2021 Washington State Energy Code Development Energy Code Proposal Short Form

For editorial **Coordination, Clarifications & Corrections** only,
without substantive energy or cost impacts

Code Section # **C202, Table C402.1.3, Table C402.1.4**

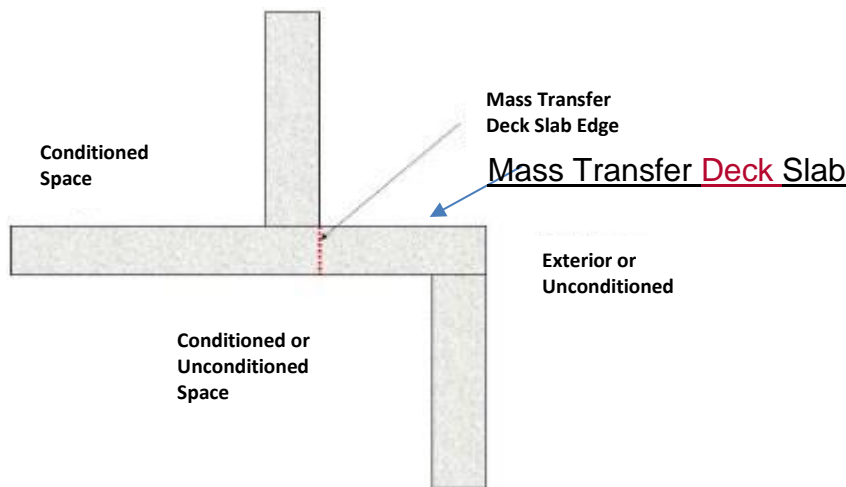
The mass transfer deck slab edge requirement in C402.1.3 and C402.1.4 is a confusing detail in the code. A mass transfer slab is a structural element. It is not the intent of the WSEC to require this slab to be thermally broken at the building perimeter wall. However, this element does contribute to thermal heat loss so the code requires that it be accounted for in the overall envelope thermal performance calculation.

This proposal incorporates clarifying language from the 2018 Seattle Energy Code for this opaque envelope element. It also clarifies that a cantilevered concrete balcony is not equivalent to a mass transfer deck slab.

MASS TRANSFER DECK SLAB EDGE. ~~That portion of the above-grade wall made up of the concrete slab where it extends past the footprint of the floor above.~~ A concrete slab designed to transfer structural load from the building perimeter wall or column line above, laterally to an offset wall or column line below, and which has conditioned or semi-heated space on the inside of the upper wall and exterior or unconditioned space on the outside of the upper wall. The area of the mass transfer slab edge shall be defined as the thickness of the slab multiplied by the ~~perimeter~~ length of the edge condition. Examples of this condition include, but are not limited to, the transition from an above-grade structure to a below-grade structure or the transition from a tower to a podium. A cantilevered concrete balcony does not constitute a mass transfer deck slab.
